Subject: GLOW AROUND WIPER SWITCH REWORK WIPER SWITCH BEZEL

Model and Year: 1981 Corvette

Source: Chevrolet Dealer Service Bulletin

Bulletin Number: 81-I-19

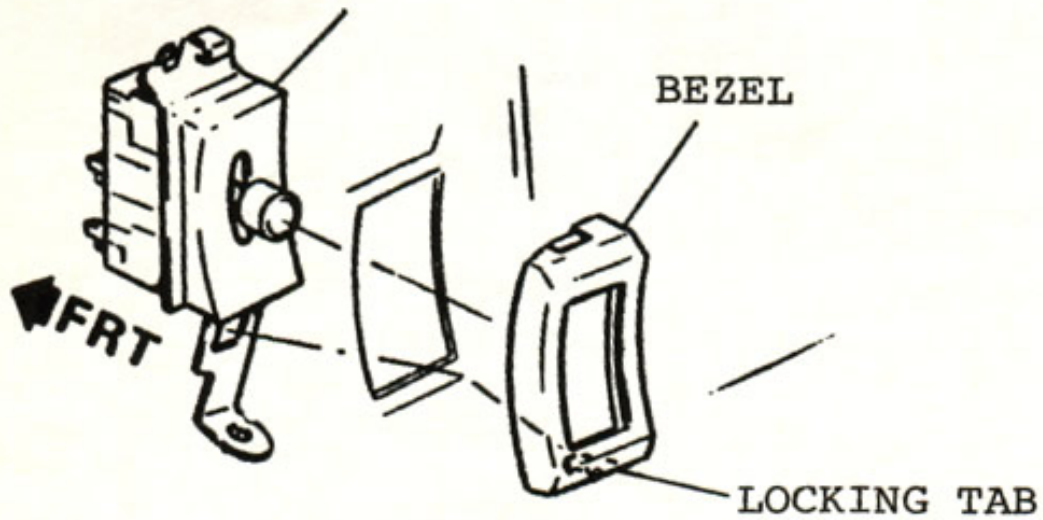
SOME EARLY 1981 CORVETTES WITH SILVER, RED, OR RUST TRIM MAY EXHIBIT A GLOW AT NIGHT AROUND THE WIPER SWITCH BEZEL. IN THESE COLORS, THE BEZEL BASE MATERIAL IS "NATURAL" AND COULD BECOME TRANSLUCENT WITH LIGHTS TURNED ON. THE REMAINING BEZEL COLORS WERE PAINTED OVER A BLACK BASE MATERIAL AND ARE NOT AFFECTED.

THE GLOWING CONDITION CAN BE ELIMINATED BY REPLACING THE ORIGINAL BEZEL WITH P/N 14016216, WHICH IS BLACK AND MUST BE PAINTED TO MATCH TRIM COLOR. THE BEZEL HAS A LOCKING TAB WHICH ENGAGES THE WIPER SWITCH AS ILLUSTRATED ON PAGE 2.

CORVETTE WIPER SWITCH BEZEL ATTACHMENT

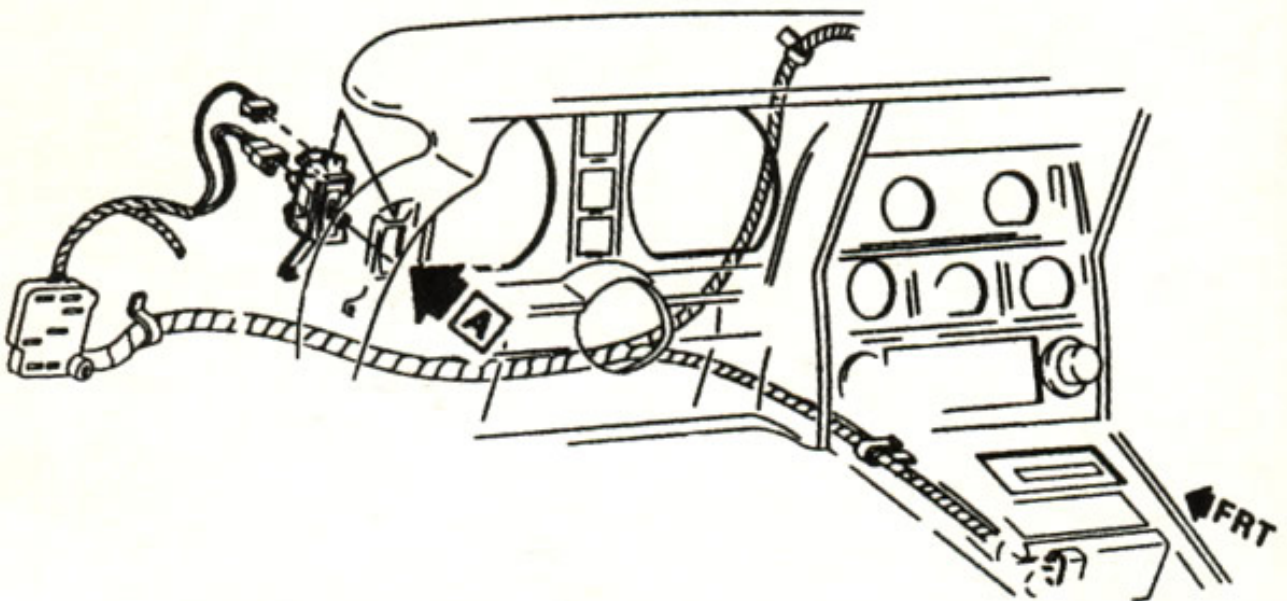
REPLACEMENT REQUIRES SETTING THE STEERING COLUMN TO ITS LOWEST TILT POSITION, REMOVING THE SPEEDOMETER CLUSTER, AND REACHING THROUGH THE INSTRUMENT PANEL TO DISCONNECT THE BEZEL LOCKING TAB.
